Assessment & Abandoned Mines
Ministry of Energy, Mines and Resources
FARO MINE COMPLEX
SITE-WIDE ELECTRICAL ASSESSMENT

INTERIM REPORT

Rev 0, Original Issue 31 August 2016
Rev 1, Minor Corrections Issued 29 November 2016

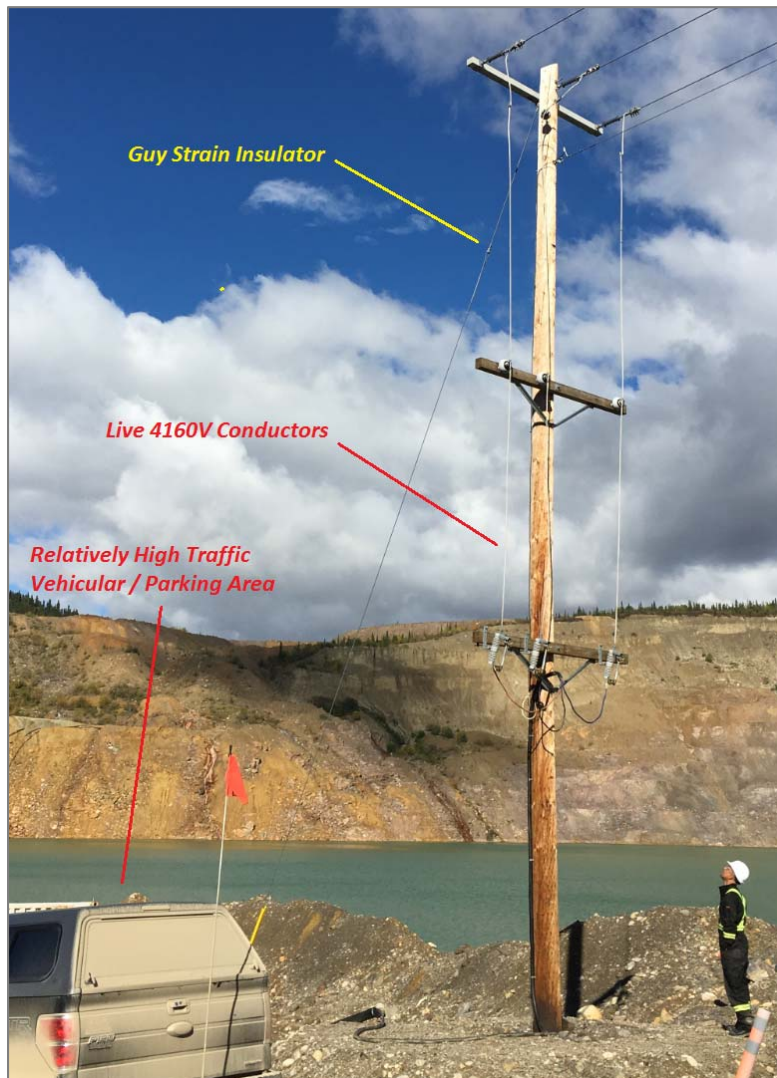
Left: This 100A S&C Type XS fuse is improperly sized for the 225kVA transformer at the Van Gorda WTP

Transformer rated amperage at 4160V is just 31A, code allows a maximum standard fuse size of 50A. The oversized fuse results in excessive arc-flash hazard on the 600V side of transformer due to slow clearing time.

Right: Typical 4160V aged fuse & porcelain holder. A number of these should be replaced with new fuses in polymer insulated holders. Having known documented fuse sizes allows for certainty in the arc-flash calculations.

With the above points in mind, we will be producing a list of recommended replacement fuses and holders for operating locations that could be changed by an overhead line contractor.
